**Fortescue - Solomon - Dec 2010 Peer Review (Hydroconcept)**

**Peer review and model appraisal**

**Hydrogeological Assessment  
of the Solomon Project**

**14<sup>th</sup> December 2010**

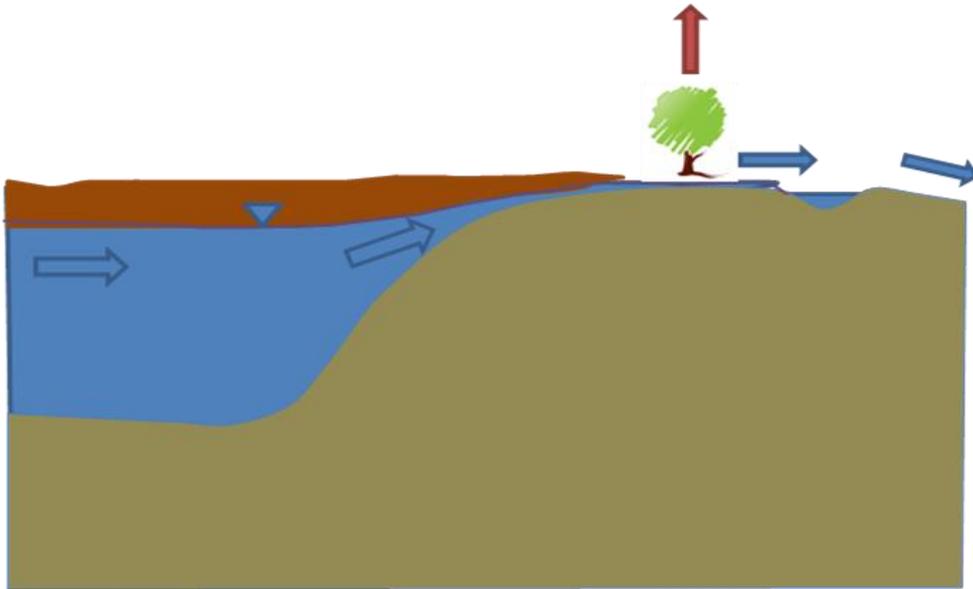
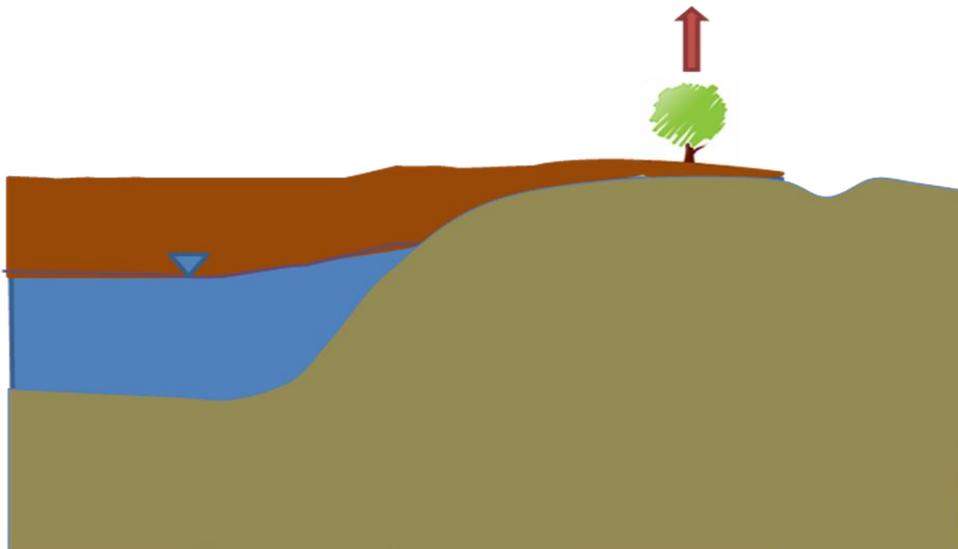
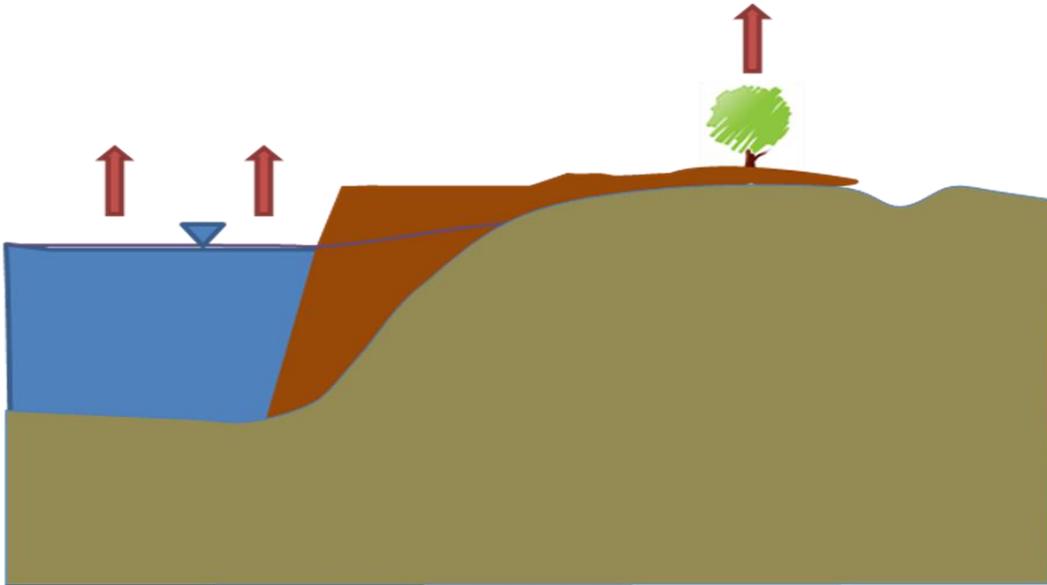
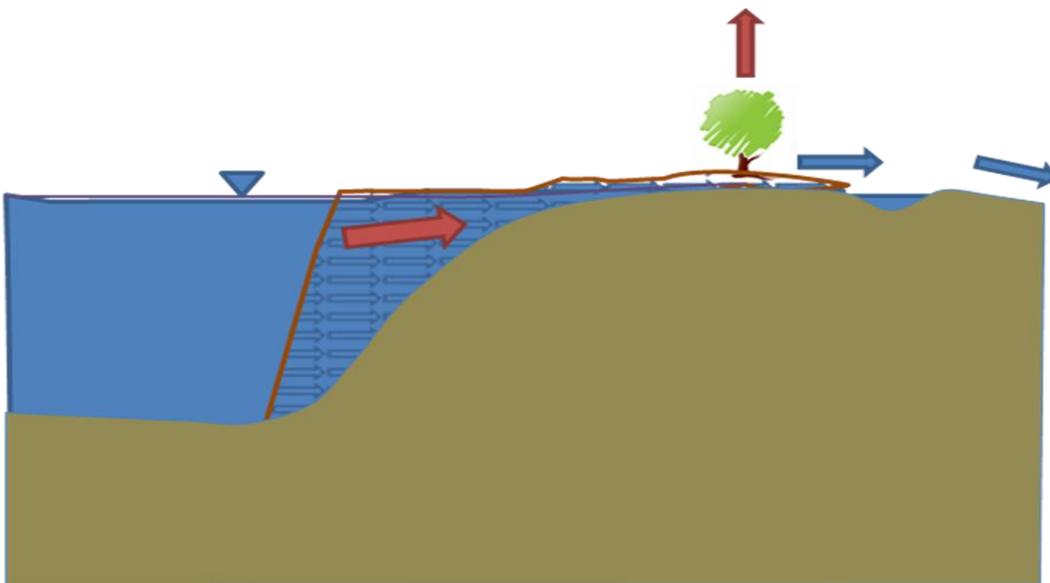
Schematic illustration highlighting the relationship between water levels in the CID and the pools would be extremely useful. The author has provided some illustrations as to assist with explaining the linkage and the importance of water level geometry and stage height for supporting the downgradient pools and associated vegetation.

There is also no discussion about post-mining impacts on water levels in the remaining / rehabilitated CID, the creation of pit lakes and long-term functioning of the pools. It is likely that dynamics within the pit lakes will have an impact on water level and potentially water quality in the pools. Indicative post-closure illustrations have been developed by the author.
